Appl. No.: 09/747,920

Amdt. dated October 28, 2004

Reply to Office Action of July 29, 2004

**Amendments to the Drawings:**

**FIG. 4**

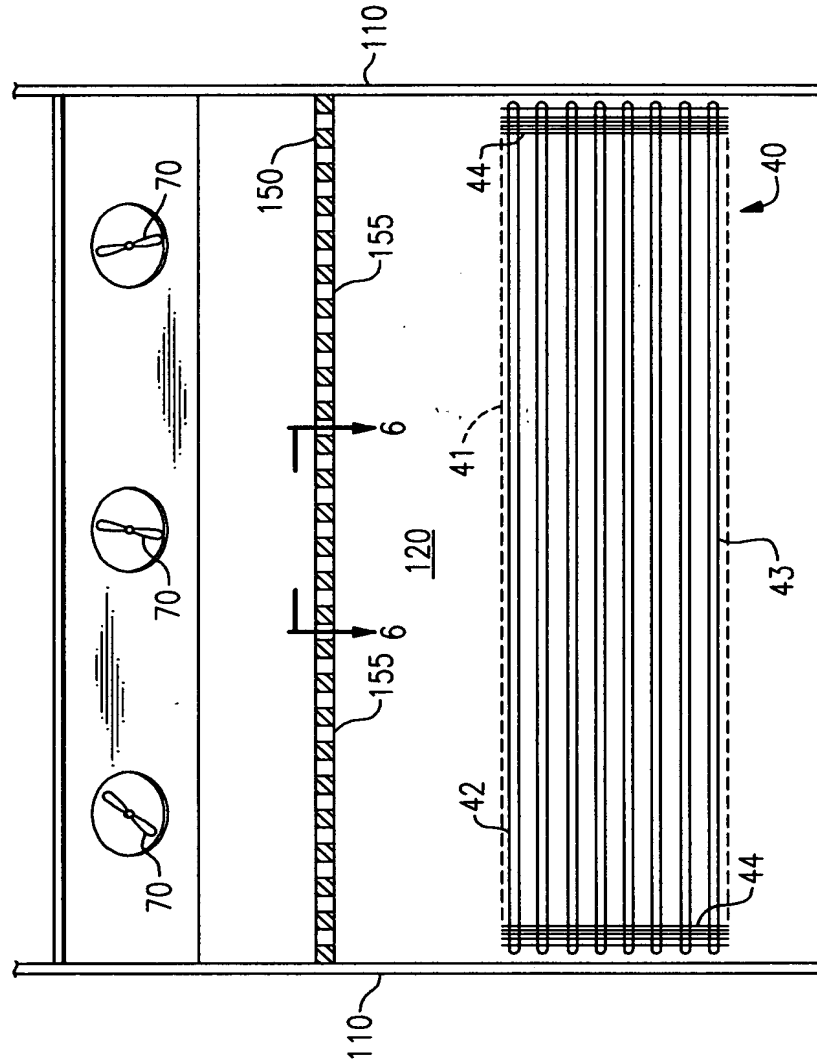
The Replacement Sheet, which has been amended to include new section line 6-6 and to show the fan plate associated with fans 70 with proper shading and orientation, replaces the original sheet including Fig. 4. An annotated sheet showing these changes to Fig. 4 is appended to this paper following the Remarks/Arguments section hereof.

**FIG. 6A**

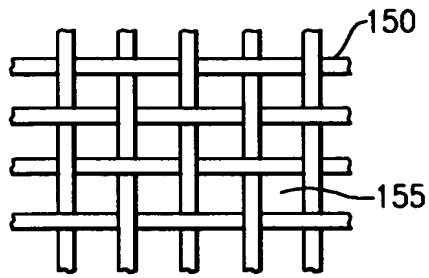
The accompanying New Sheet being added includes new Figs. 6A, 6B and 6C in response to the Examiner's objection the drawings. New Fig. 6A shows the flow baffle 150 as a "screen mesh member" as recited in Claim 4. New Fig. 6B shows the flow baffle 150 as a "slotted planar member" as recited in Claim 5. New Fig. 6C shows the flow baffle 150 as a "honeycomb structure" as recited in Claim 6. Applicants submit that no new matter has been added.
